## COMMITTEE OF EXPERTS ON THE TRANSPORT OF DANGEROUS GOODS

Corrections to ST/SG/AC.10/C.3/2000/46 and Comments on ST/SG/AC.10/C.3/2000/34

### Extremely Flammable Criteria, Determination of the Ignition Distance of the Spray Jet

Transmitted by the Expert from the United States

**Figure 1 Note: This figure portrays the aerosol in an upright position, however the aerosol should also be tested in horizontal and inverted positions.**

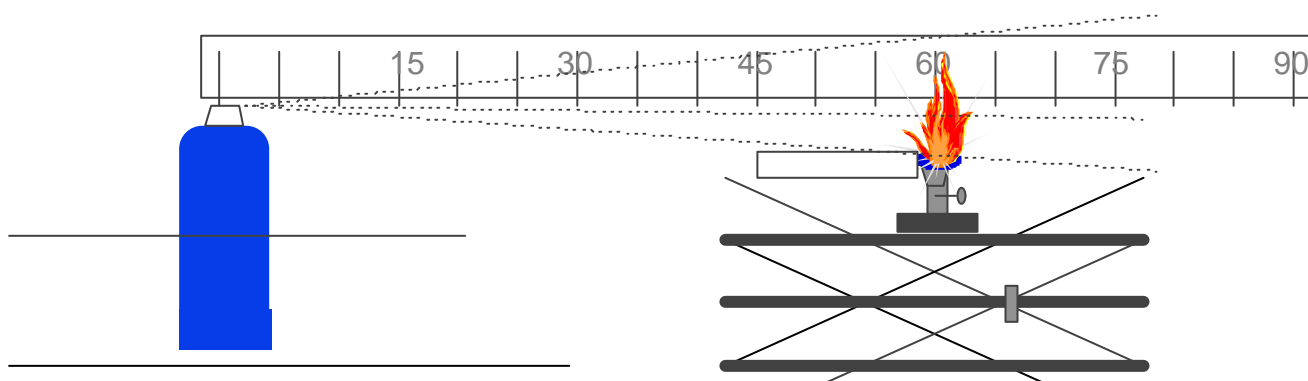
8. Level the actuator's orifice and burner flame, ensuring that the orifice is properly directed towards and aligned with the flame (see Figure 1). The spray shall be expelled through the top half of the flame.
